HISTORIC AND DESIGN REVIEW COMMISSION

HDRC CASE NO: 2016-409
ADDRESS: 318 W HUISACHE AVE
LEGAL DESCRIPTION: NCB 2952 BLK 1 LOT E 48 FT OF 7 & W 24 FT OF 8
ZONING: R-4 H
CITY COUNCIL DIST.: 1
DISTRICT: Monte Vista Historic District
APPLICANT: Maria Garcia
OWNER: Maria Garcia
TYPE OF WORK: Construct rear accessory structure
REQUEST:

The applicant is requesting a Certificate of Appropriateness for approval to construct a wood pergola in the side yard set back from the main structure with 127 square feet of cobblestones beneath to example an existing patio area.

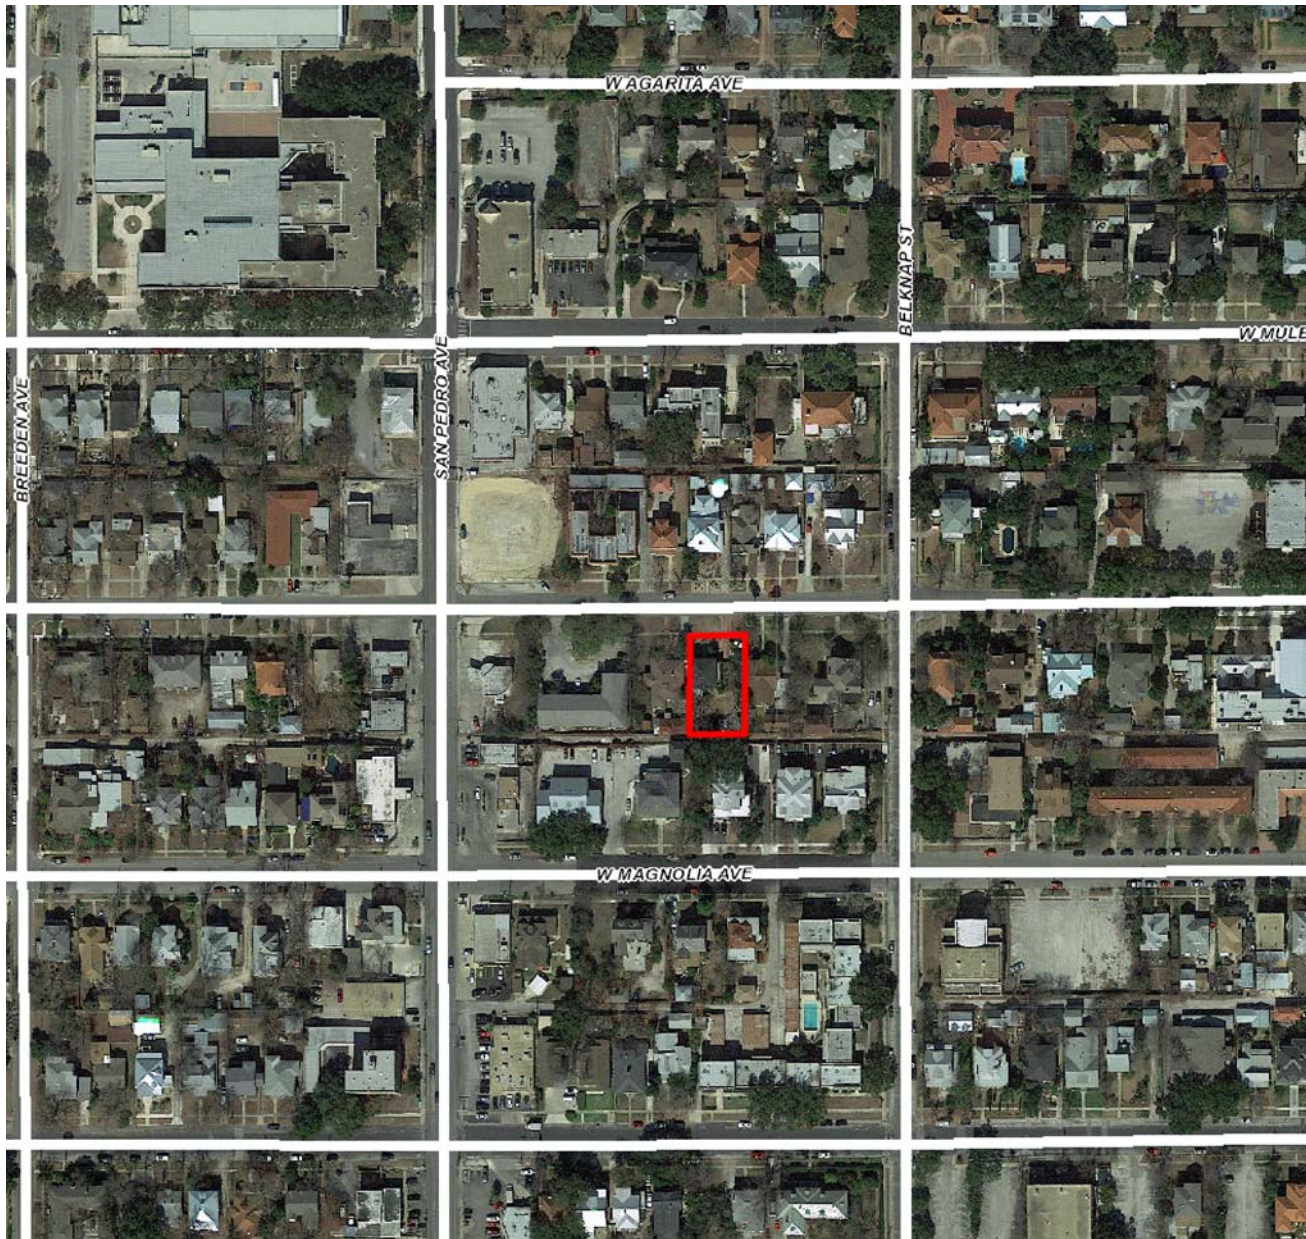
be visually subordinate to the main structure. Staff finds the proposed 10' pergola is subordinate to the main structure in height and would not be visible from the street. This is consistent with the Guidelines.

Staff recommends approval as submitted based on findings a through d.
